ADDENDUM

No. 03 Date: 9/11/2024
Project No. 0020711.01 Attention: Leonard D'Souza
Project Name: Princess Margaret Cancer Centre
Stem Cell Transplant 2, MHC, MHDU, DSC
Address: University Health Network
610 University Avenue
Toronto ON

This Addendum forms a part of the Bidding and Contract Documents and modifies the original issued Bidding Documents (dated August 13, 2024) for the above titled project, as indicated below, and is hereby incorporated into the Contract Documents as part thereof.

G0502

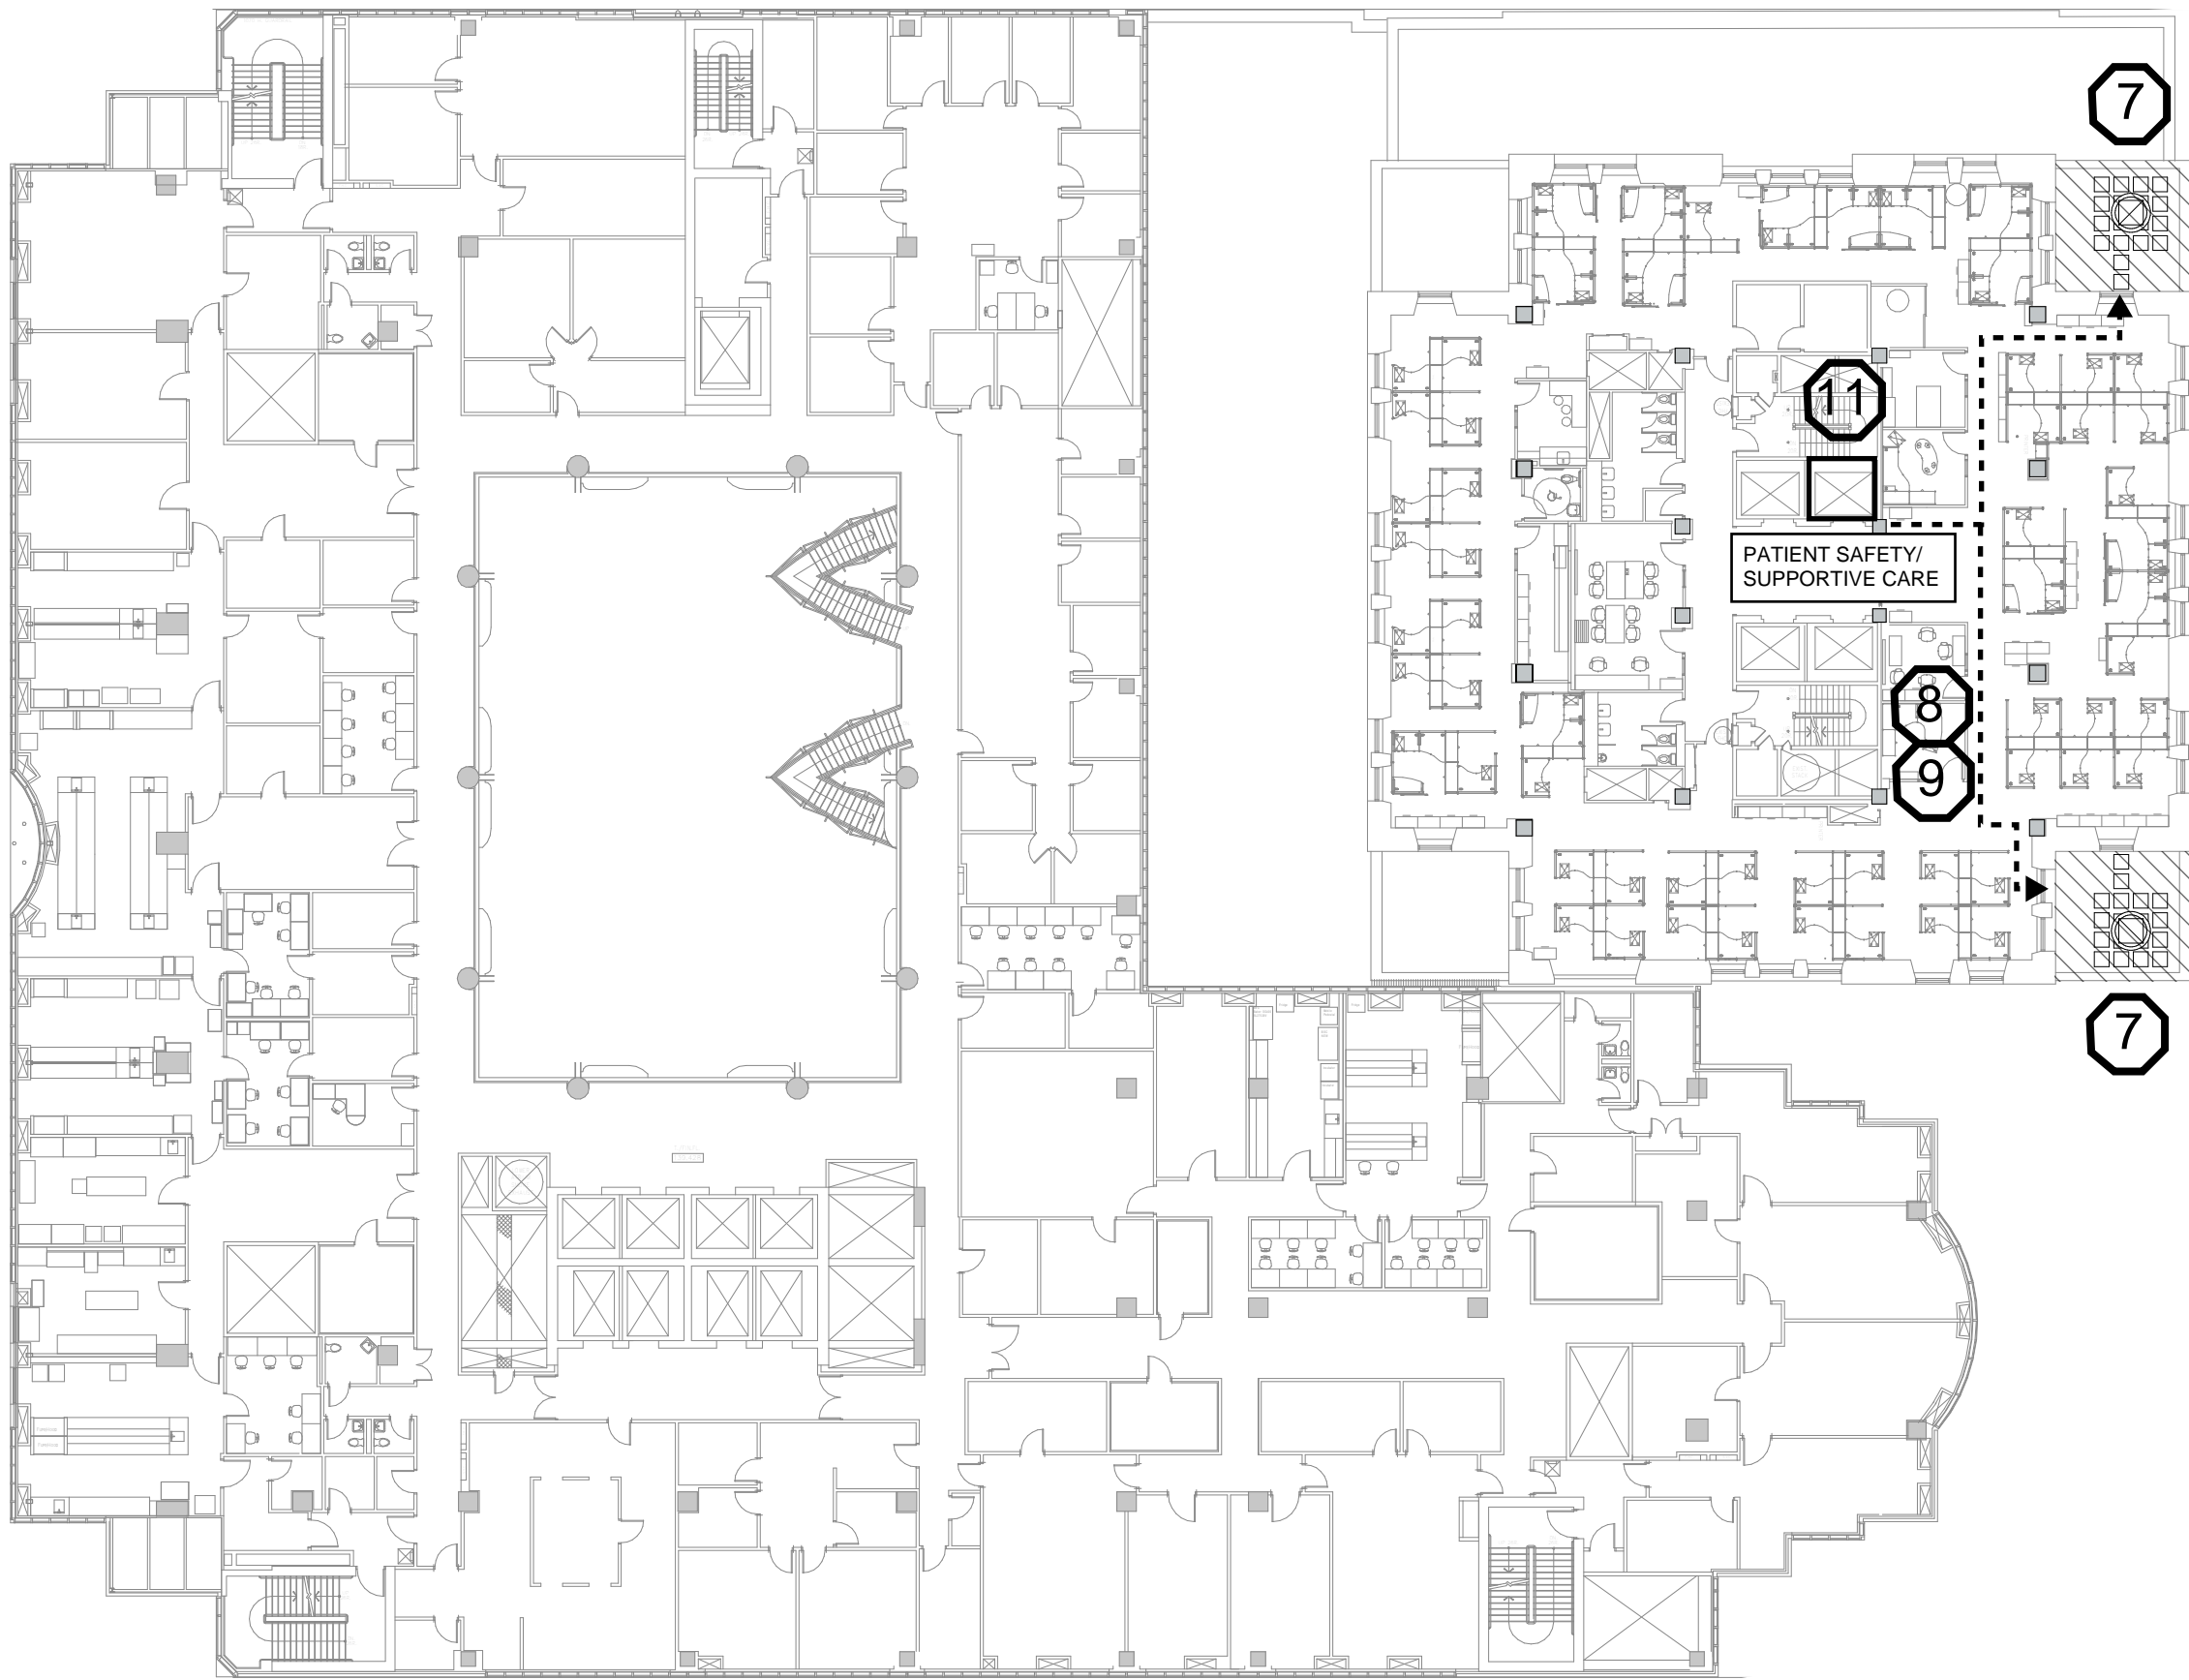
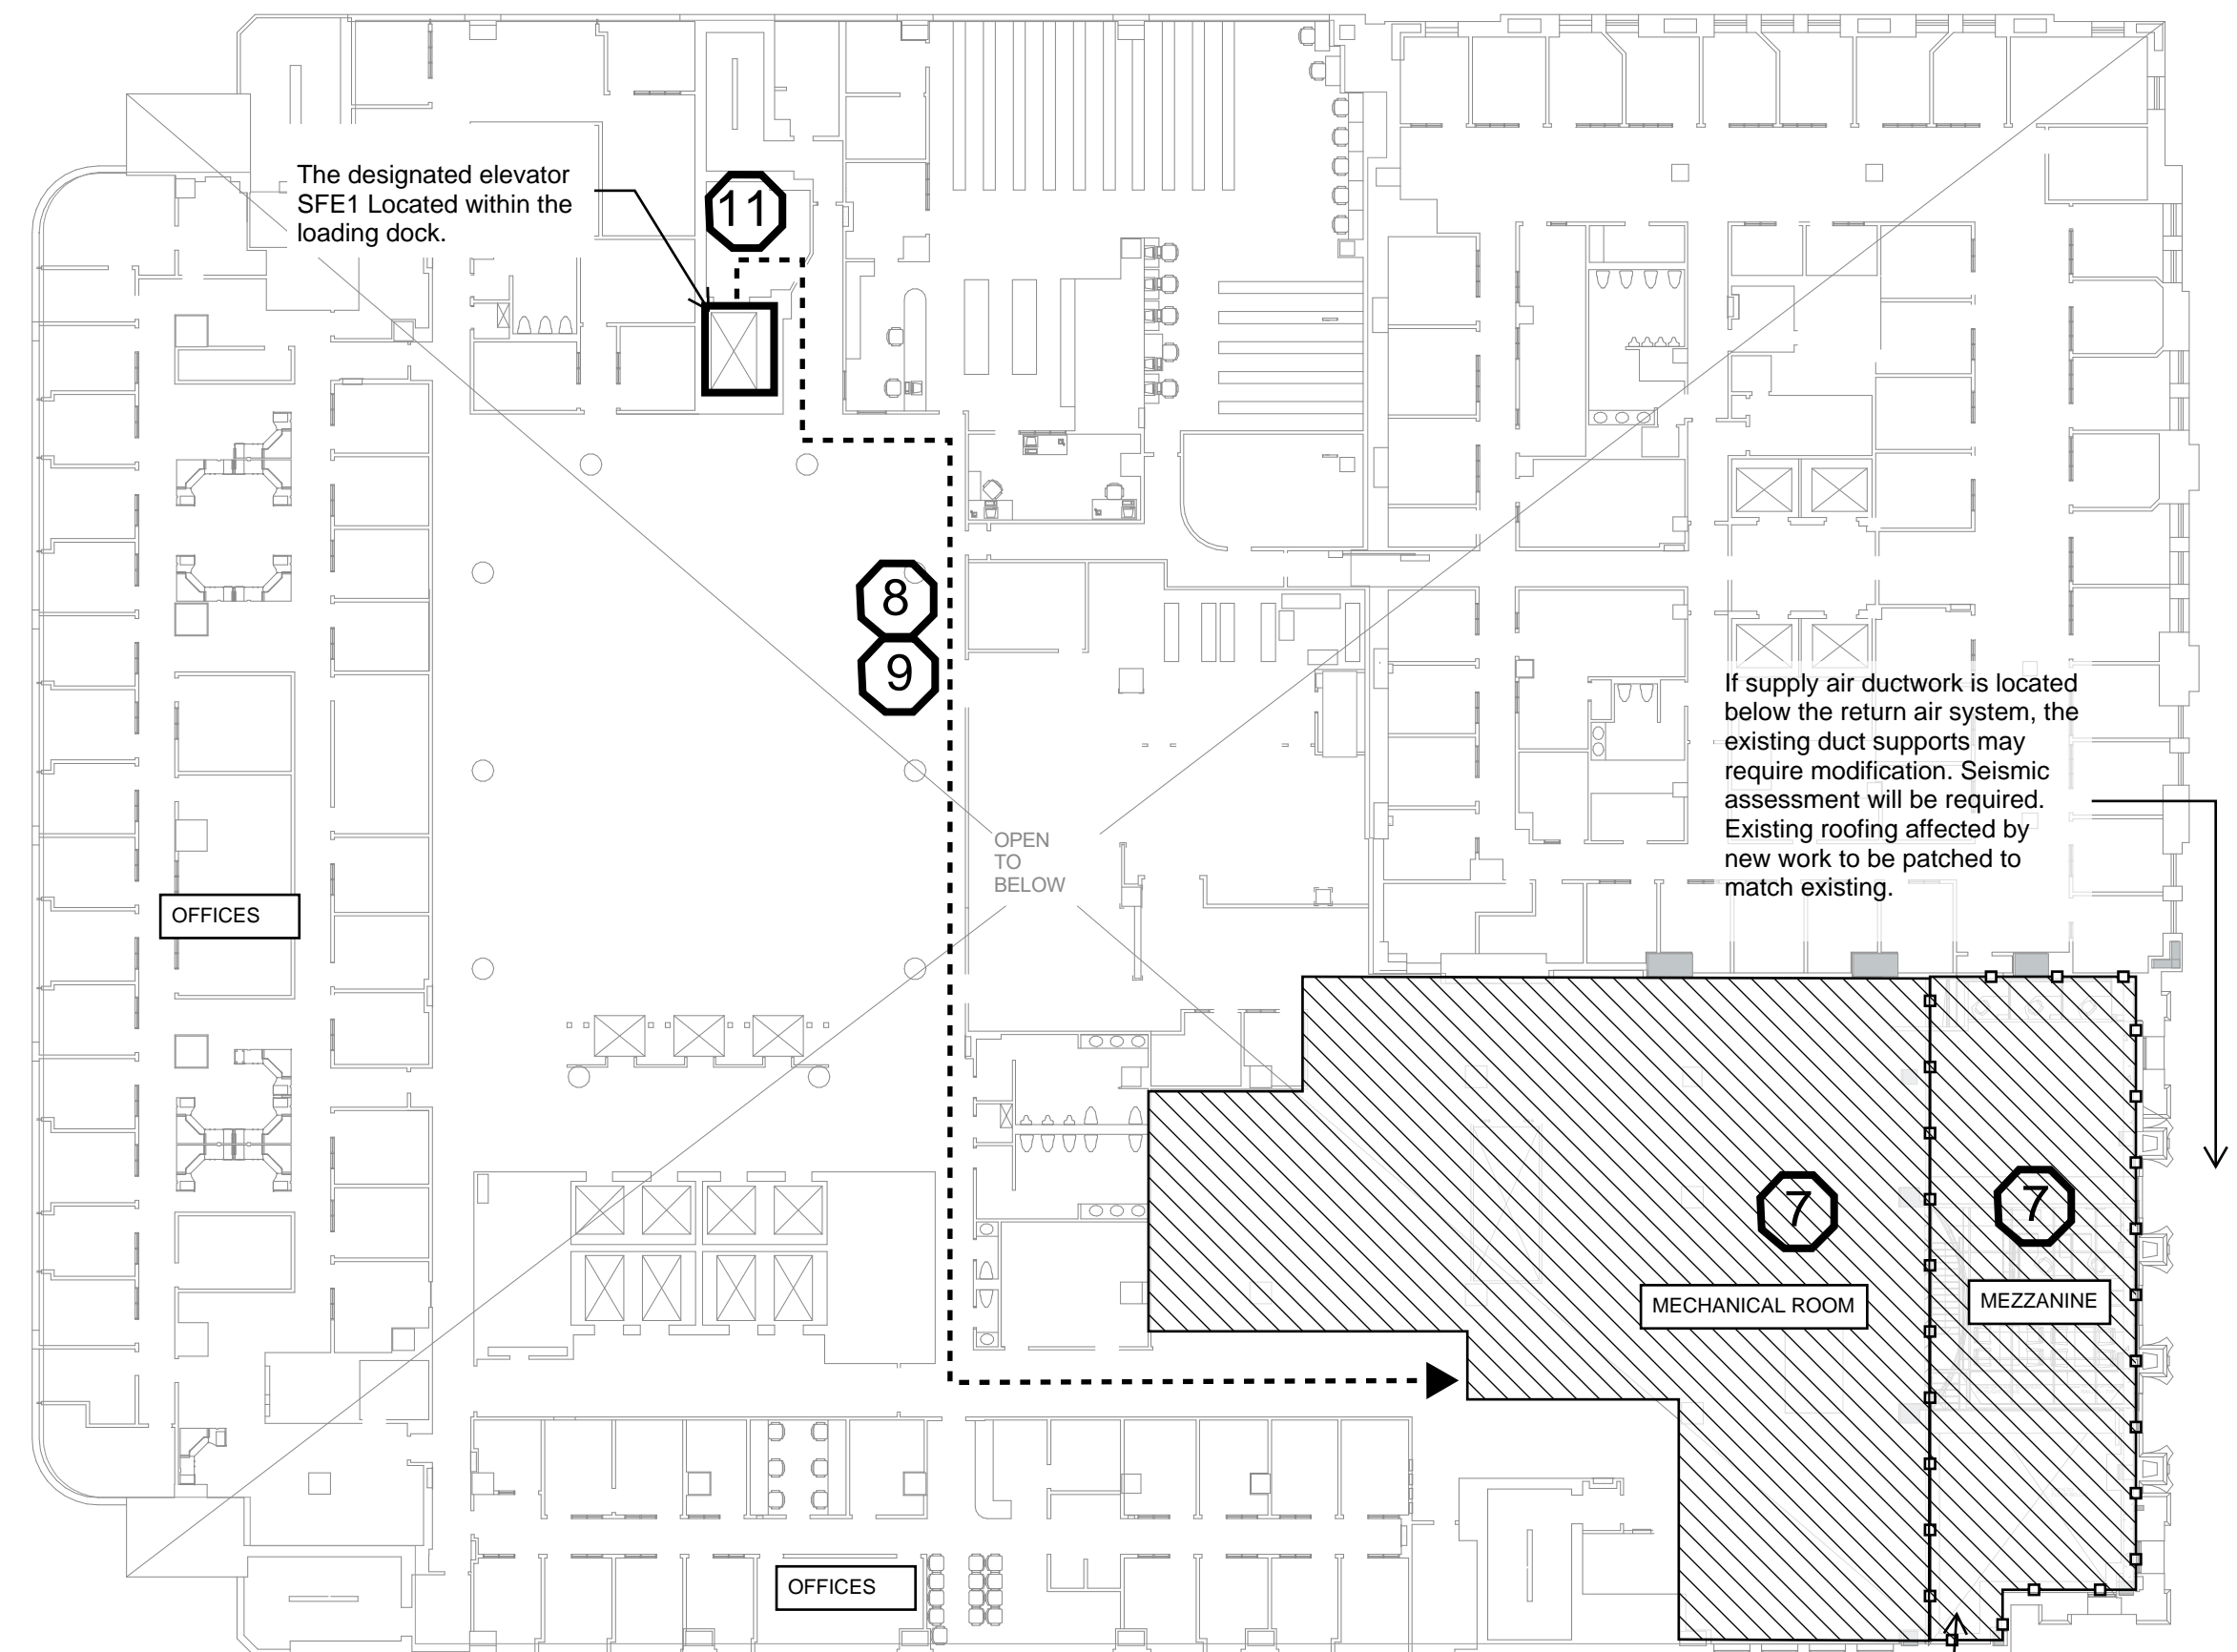
DRAWING G0502 – CONSTRUCTION CONTROL PLANS

Revised legend, added notes for exit stairs, ceiling types, limitation on Level 9 work, occupancy of the floor.
